DUKE POWER COMPANY
OCONEE NUCLEAR STATION

PROPOSED TECHNICAL SPECIFICATIONS

JUSTIFICATION FOR RAISING SETPOINT FOR
REACTOR TRIP ON HIGH PRESSURE

**JUSTIFICATION FOR RAISING SETPOINT
FOR
REACTOR TRIP ON HIGH PRESSURE**

Figure 2.3-1

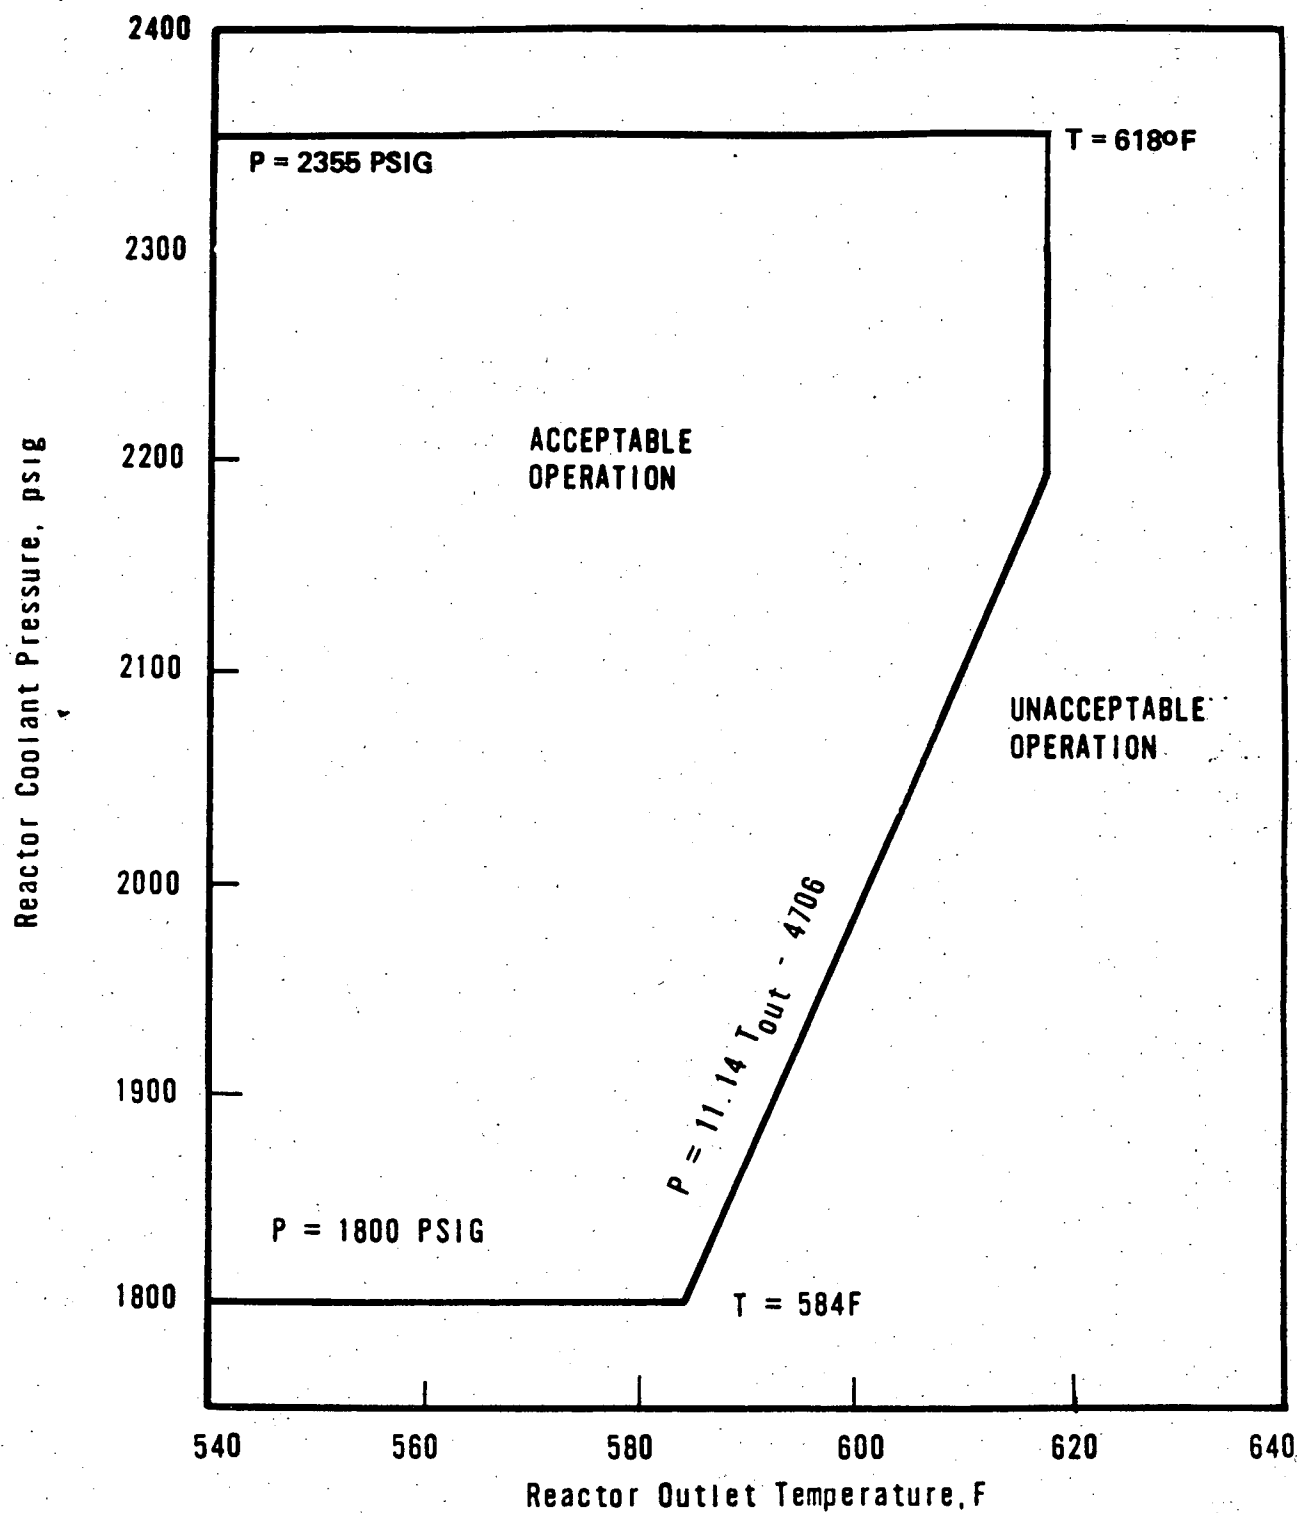
The high reactor coolant outlet temperature trip setpoint (618°F) shown in Figure 2.3-1 has been established to prevent excessive core coolant temperatures. Accounting for calibration and instrumentation errors, the safety analyses used a trip setpoint of 620°F.

The high RCS pressure trip setpoint is reduced to prevent normal operation with part of the RPS bypassed. The reactor must be tripped before the bypass is initiated since the high pressure trip setpoint is lower than the normal low pressure trip setpoint (1800 psig).
